**ADDENDUM No. 3 TO THE
FINAL ENVIRONMENTAL IMPACT REPORT
Carpinteria Valley Water District's
Water Storage Tank Project
And Rancho Monte Alegre Annexation**

September 12, 2007

PROJECT NO.
 03-039.01
 DRAWING NAME:
 SHEET 2 OF 8
 DATE:
 JUNE 18, 2007

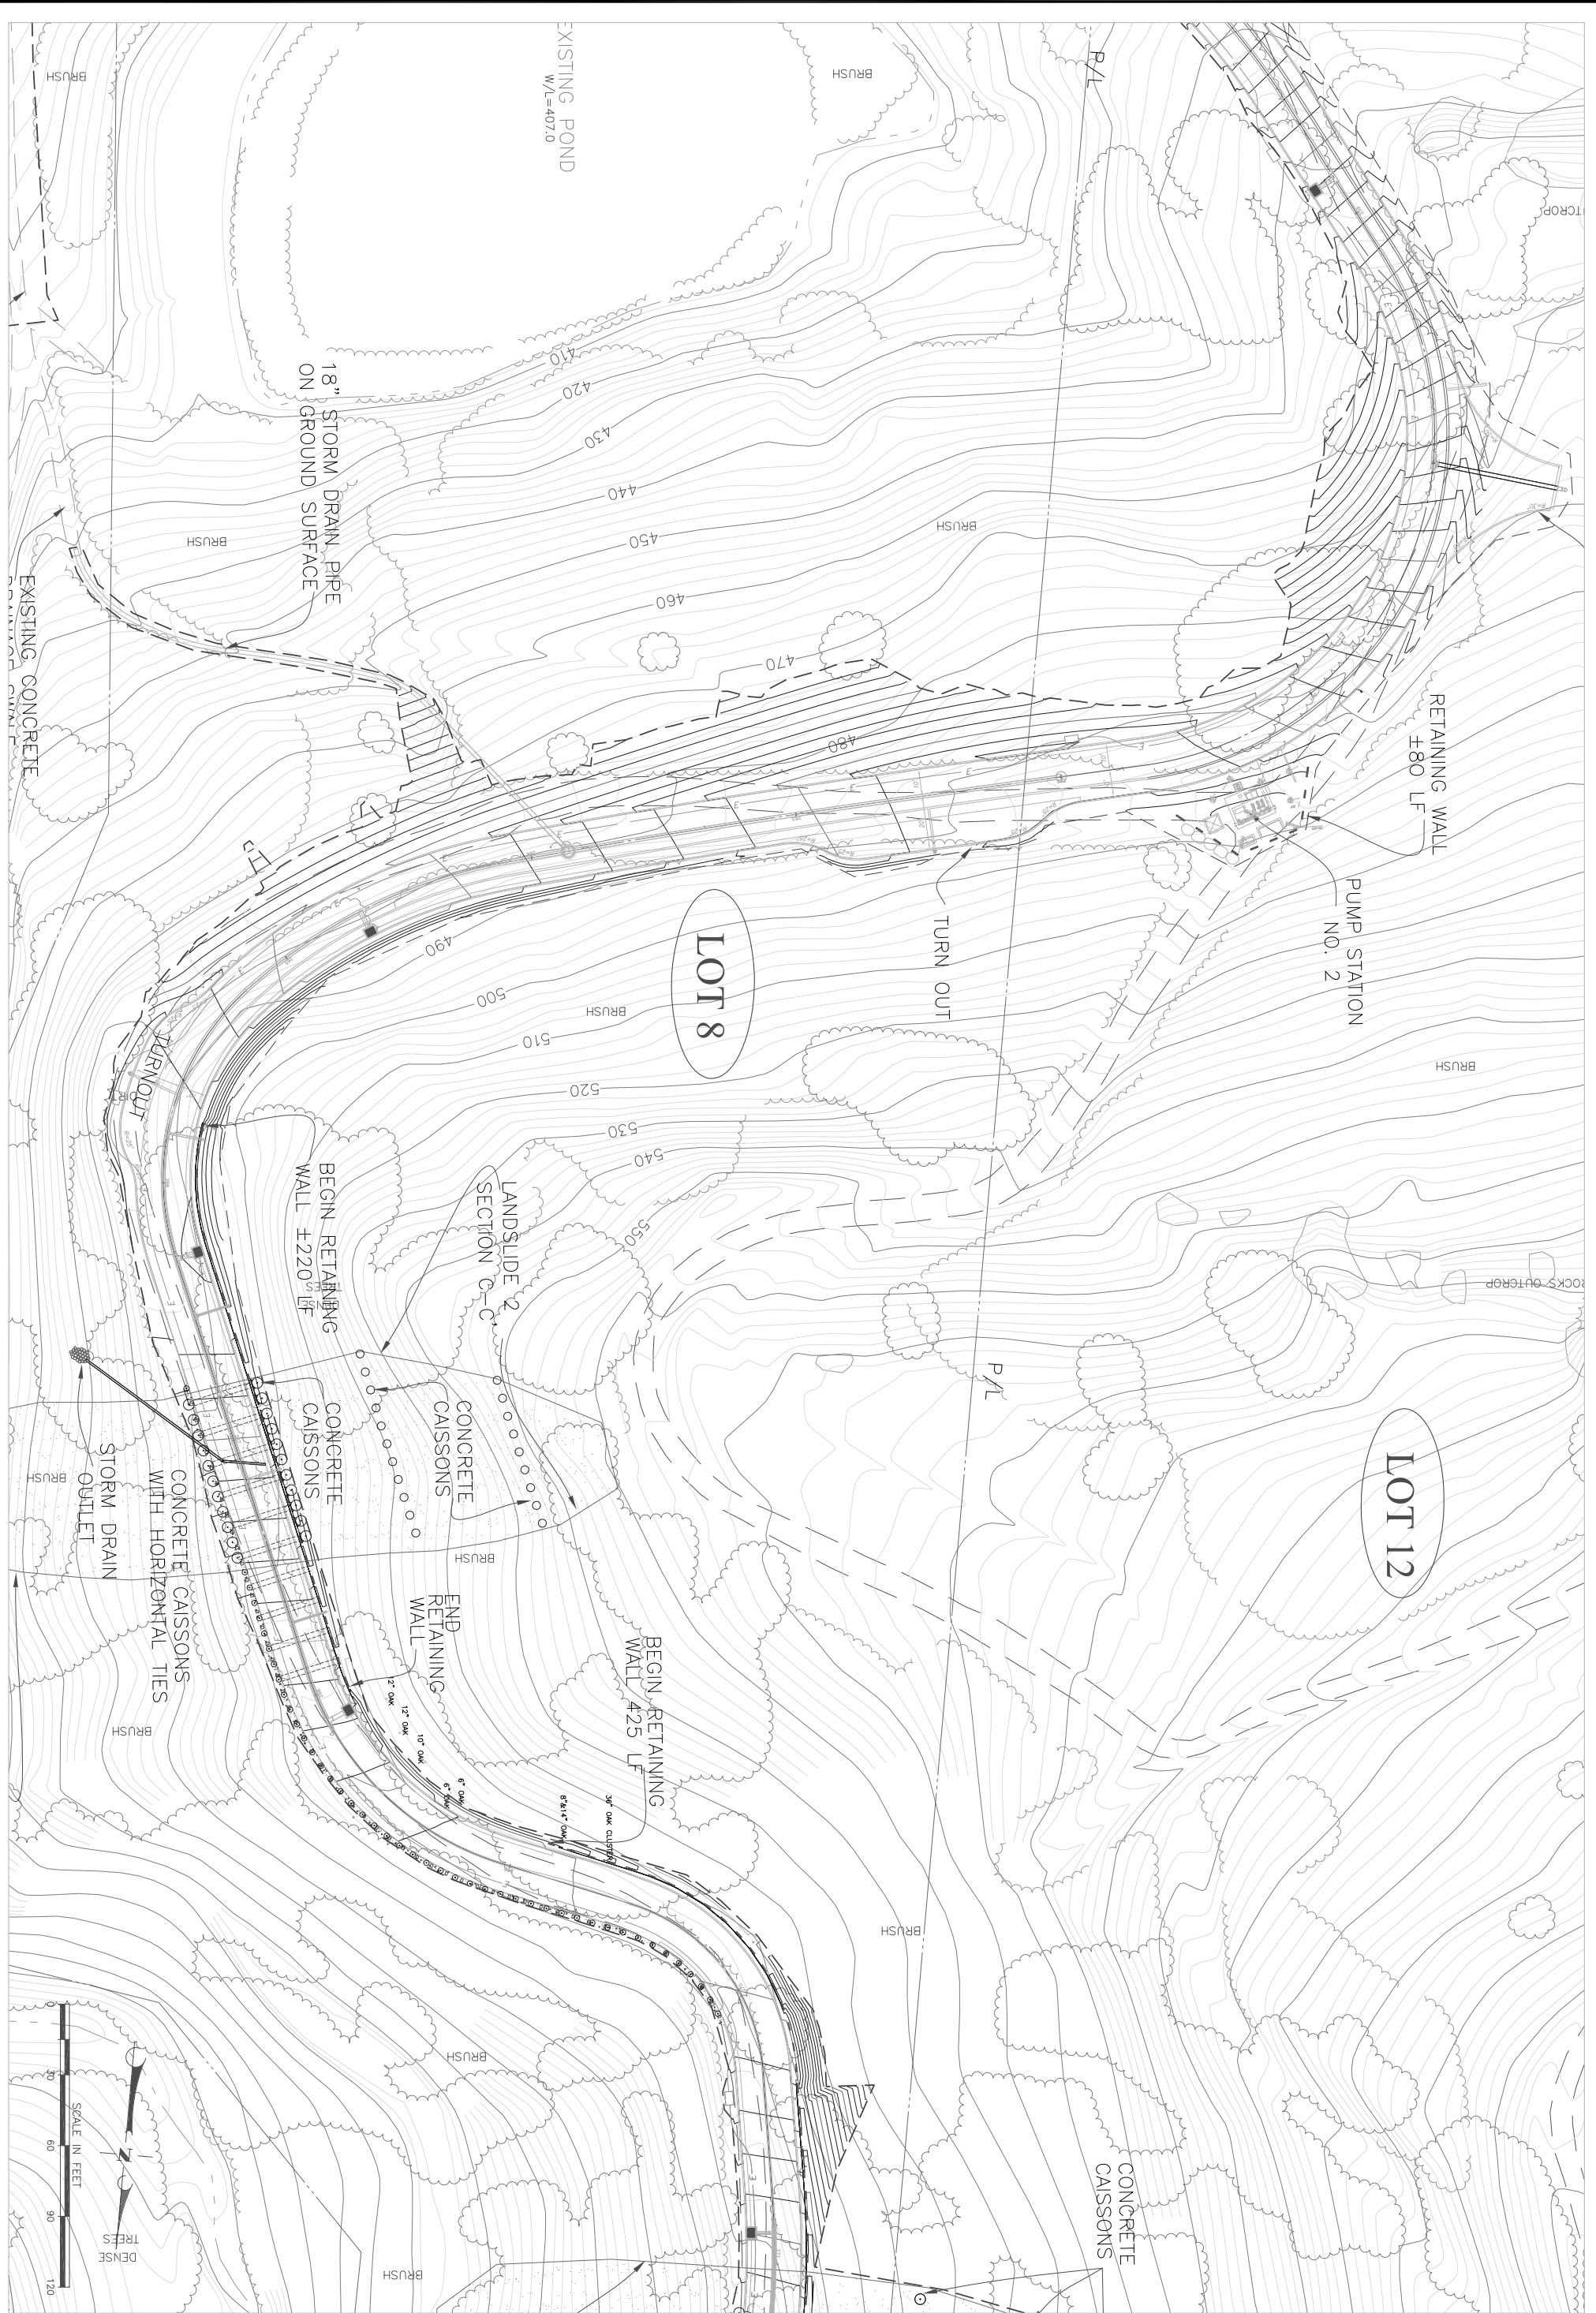
The Section A-A landslide area covers a 25-foot wide by 40-foot long area within the Phase 4 grading area. (See Sheet 2 of 8 CVWD Phase 4 & 5 Upper Tanks Access Road RMA provided in the Attachments Section of the Addendum.) The depth of the slide area is estimated to be about 10-foot maximum. The remediation as recommended by the project geotechnical reports is to scarify the road subgrade to a depth of 2-feet, and to remove and recompact soil within the grading limits sufficient to properly key fill slopes. The limits of grading and earthwork were addressed in Revised Addendum No. 2, and no additional work tasks or expansion of work areas for Addendum No. 2 is anticipated. However, the geologic hazard condition is identified herein with the remediation actions described below.

Construction procedures will generally consist of (i) dozer clearing of existing vegetation and removal of vegetation by dump truck; (ii) dozer scarification of grading area; (iii) excavation of toe of slope area to create slope keyway; (iv) replacement and recompaction of soil, including top soil on embankment areas; (v) restoration planting of embankment areas with native plants pursuant to restoration plan specifications.

PROJECT NO.
 03-039.01
 DRAWING NAME:
 SHEET 3 OF 8
 DATE:
 JUNE 18, 2007

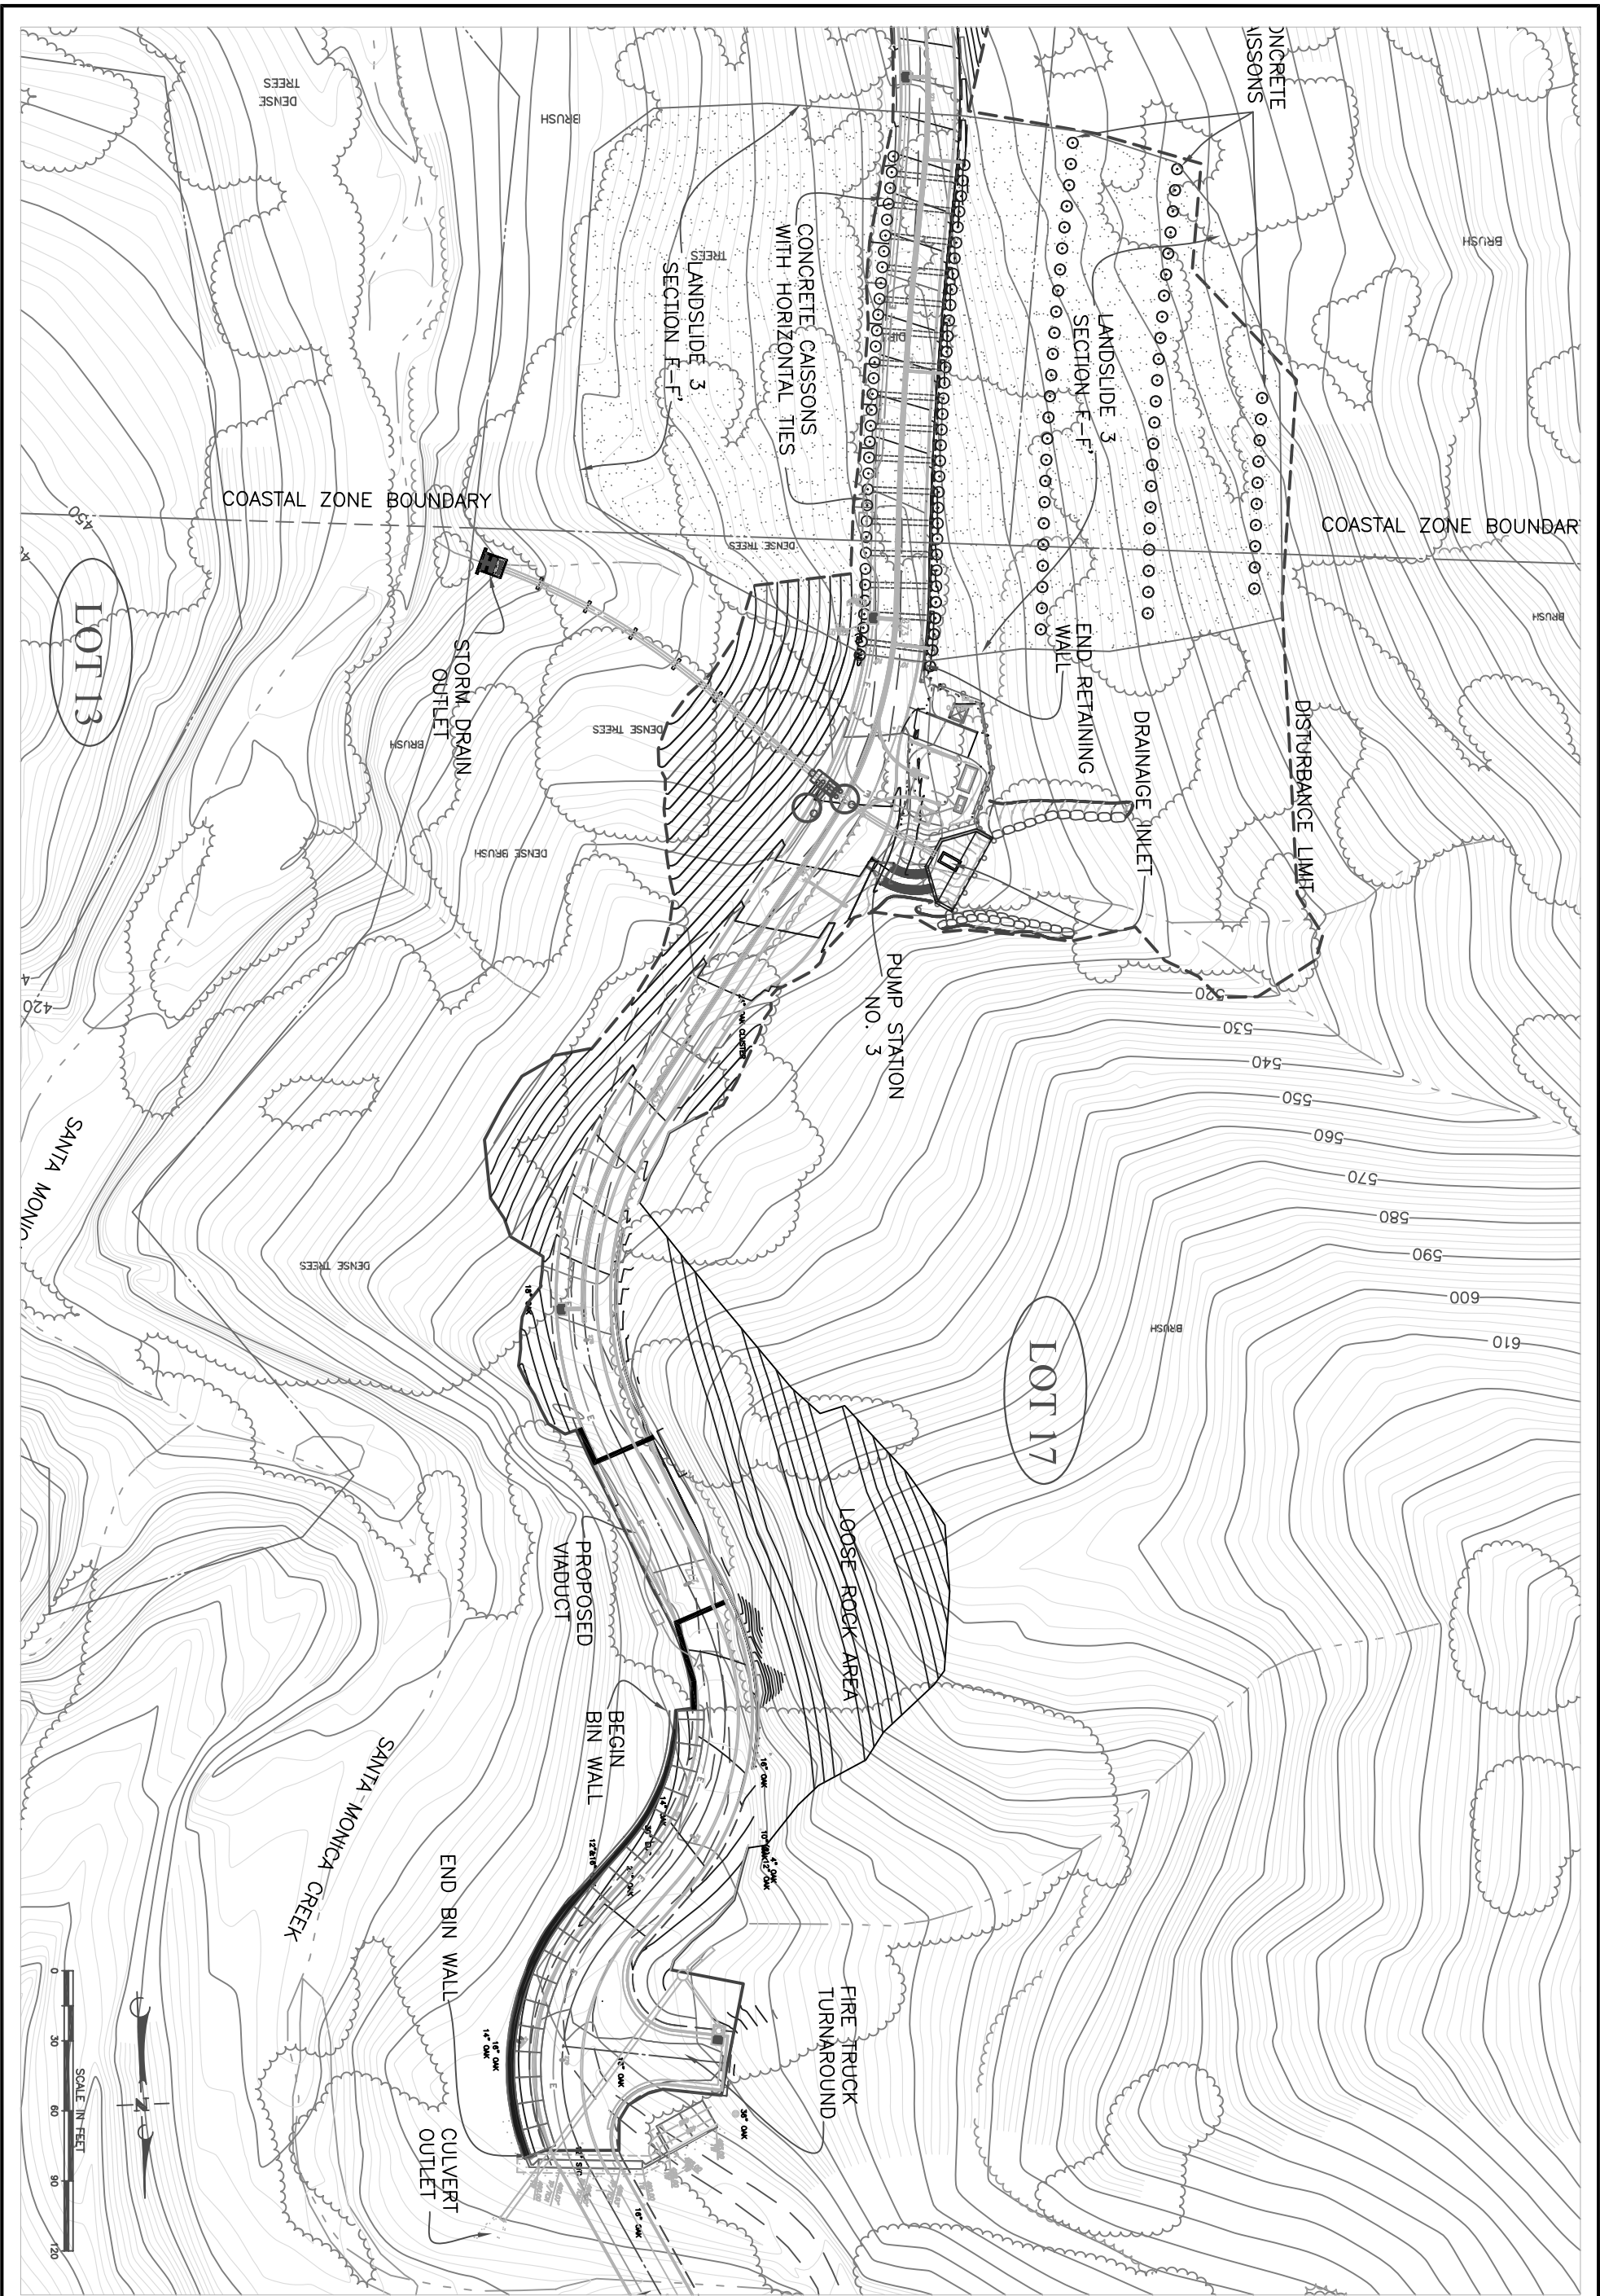
Landslide C-C is described by Earth Systems (January 18, 2007) as 250 feet long, 60 feet wide and about 8 feet thick where it crosses the RMA access road within the Phase 4 area. (See Sheet 3 of 8 CVWD Phase 4 & 5 Upper Tanks Access Road RMA provided in the Attachments Section of the Addendum.) The geologic hazard remediation proposed consists of installation of 36-inch diameter pour-in-place concrete caissons on each side of the roadway corridor through the geo-hazard area, and the option of either the installation of 30-inch diameter pour-in-place caissons aligned in two rows upslope and westerly of the access road or the installation of drilled 6-inch diameter steel tie backs with compression plate. The caissons are design to be imbedded a minimum of 10-feet into underlying bedrock. The caissons on the westerly side are located behind the retaining wall to stabilize the retaining wall. The caissons on the easterly side of the road are located under the curb and wall. The two (2) rows of caissons upslope and westerly of the roadway improvements are design to stabilize the geo-hazard mass as detailed in the geotechnical studies provided. Each pair of road side caissons has an upper and lower lateral tie back beam to further stabilize the caissons. The project area roadway between caissons will contain paving, walls, curbs, utility conduits and improvements, and undergo grading and excavation, as identified in the project FEIR and subsequent addendums. However, the geologic hazard condition is identified herein with the remediation actions described below.
